# Intel Technical Advisory

TA-0921-2

## AXXRSBBU4 Thermistor Mechanical Damage Results in Incorrect Battery Temperature Being Reported.

AXXRSBBU4, MM# 891157

Figure 1

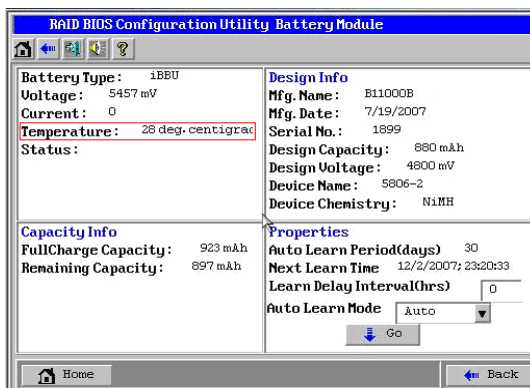
Intel has found that some AXXRSBBU4 may experience an issue with a damaged thermistor. The thermistor damage results in extreme battery temperature values being reported which results in triggering the BBU overheating protection mechanism and prevents the battery from charging. The typical symptom of this issue is a temperature value ~65512 degrees C; however, a value below 16 degrees C can also be reported.

Temperature values reported by the thermistor can be viewed in RAID BIOS Console utility (see Figure 1) or in the RAID Web Console 2 utility (see Figure 2).

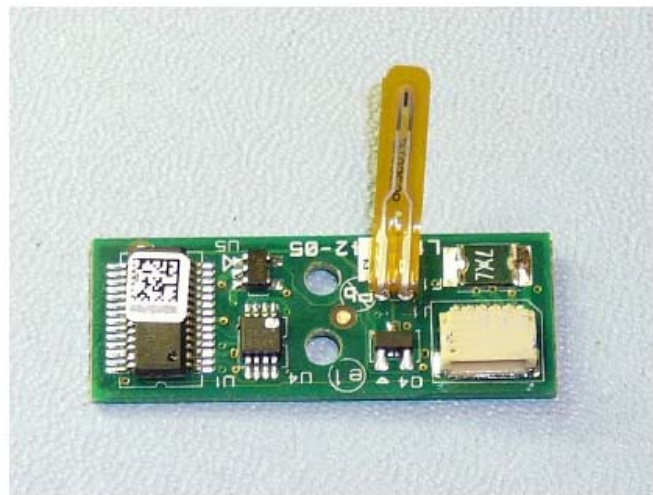
Figure 5 shows damaged detected in the thermistor elements.

Additional analysis of these fractures proved that separation of the element along the fracture line results in incorrect values being reported to the gas gauge circuitry.

Product with MM#891157 is no longer in production and has been replaced by product with MM#899346 which is based on LiON battery technology. An additional functional test has been implemented for this updated product that includes a test designed to catch damage to the thermistor, and a plastic shroud has been added to provide additional protection to the thermistor and battery cell pack.

**Figure 3 : Gas Gauge and Battery assembly**

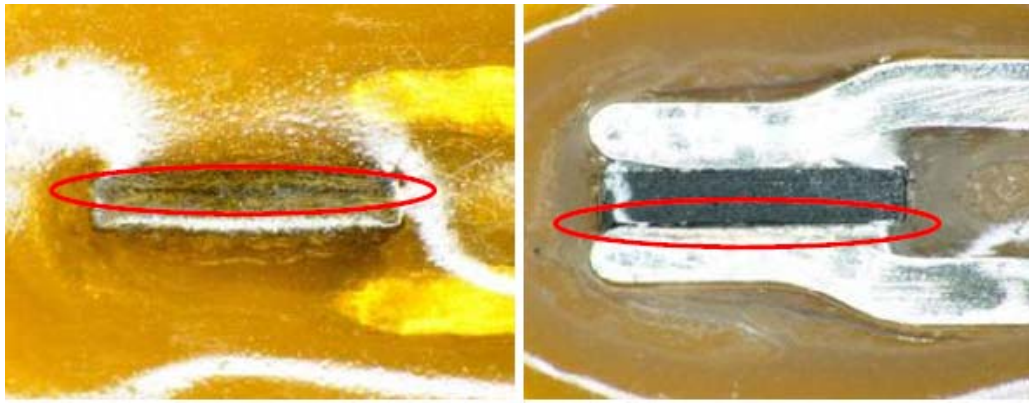
Cause of the thermistor damage has been determined to result from improper handling at the last stage of the test process. Pictures below show the disassembled thermistor and battery cell pack in figure 3, and the gas gauge circuit board with thermistor attached in Figure 4.
